TECHNICAL INFORMATION

Date: 31.12.2025
 TI: 1925
 Vending machine type(s): SiLine HG TS Series

SiLine cable fastening HG TS Series

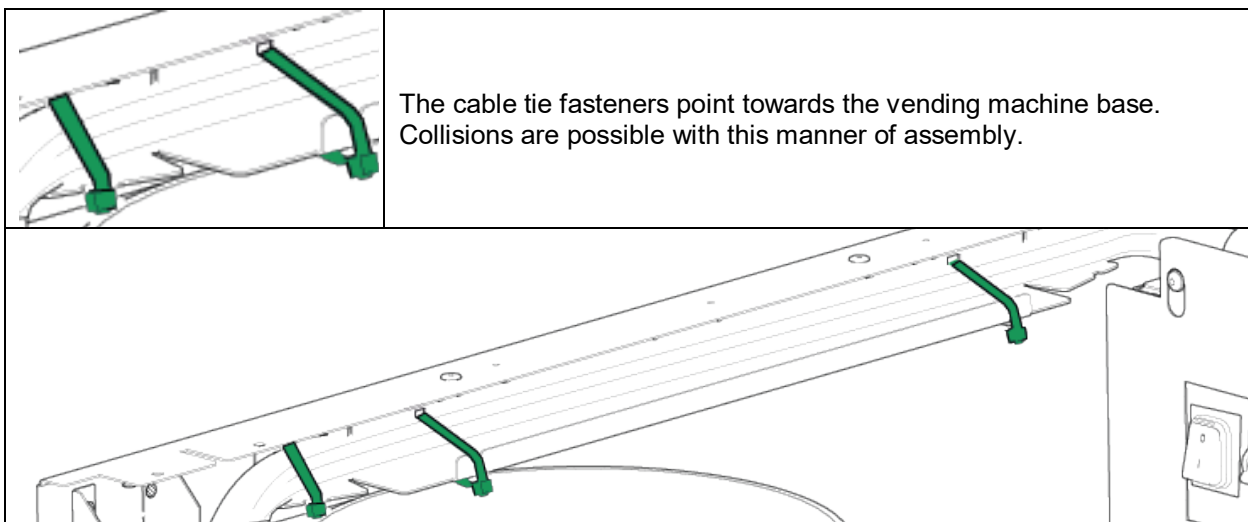
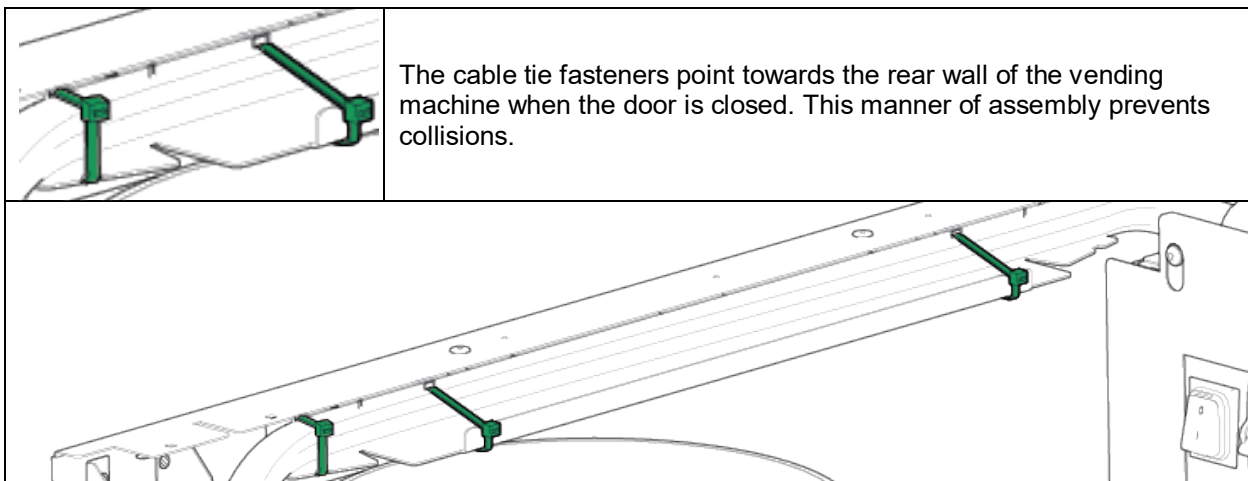
The cable harness holder (housing, item no. 419 00 410 00) has been modified and extended as part of product optimisation.

The modification aims to improve cable routing in and around the cable tray and to reduce potential collisions with moving components.

The modified cable harness holder will be fitted as a standard component from production week 36/2025 (from serial number 90569753)

Irrespective of this modification, it remains necessary to ensure that the cables are laid correctly in the area of the cable tray during service and maintenance so as to prevent any interference with cup stack rotation.
